## LOW PRESSURE BALANCED CONTROL VALVE

### Product Improvements

This notice is to inform you that we have made the following improvements to **2" and 3" Kimray Low Pressure Balanced Control Valves**. These key updates mean your valves will stand up better in harsh conditions while allowing you increased flexibility and faster repair.

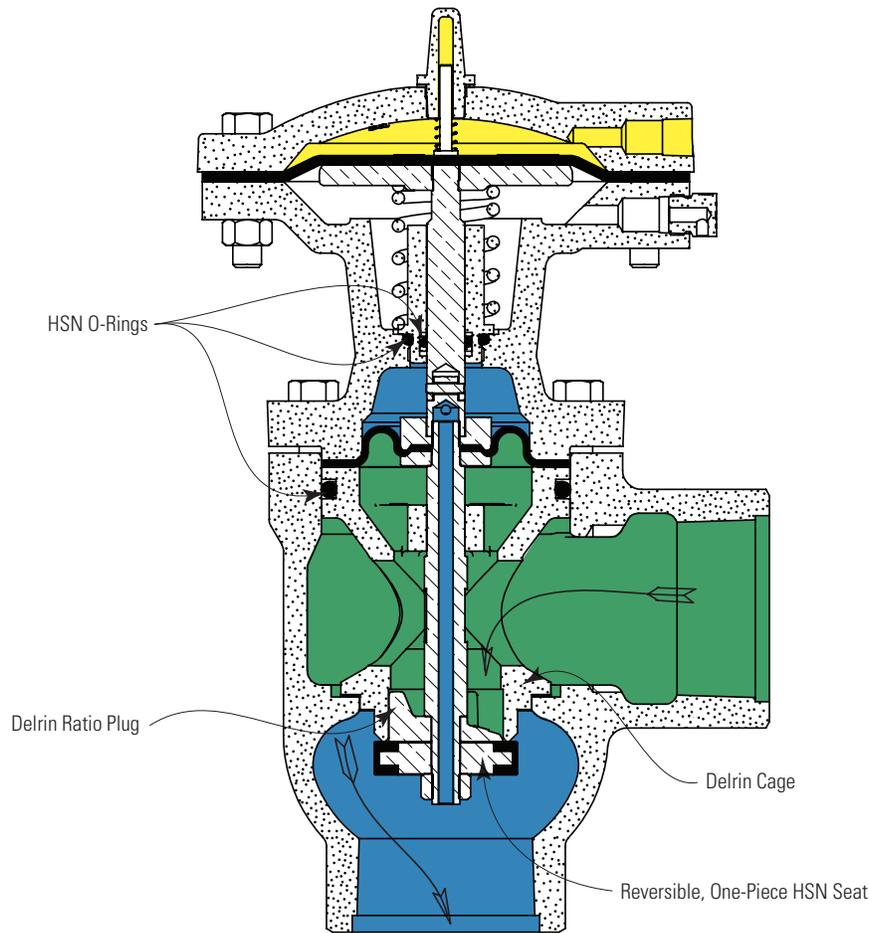
#### **2" and 3" Low Pressure Balanced Control Valves will feature the following changes:**

Reversible one-piece HSN seat with metal insert in diaphragm-balanced and piston-balanced models

Delrin ratio plug in diaphragm-balanced and piston-balanced models

Delrin cage in diaphragm-balanced model only

All O-rings changed to HSN
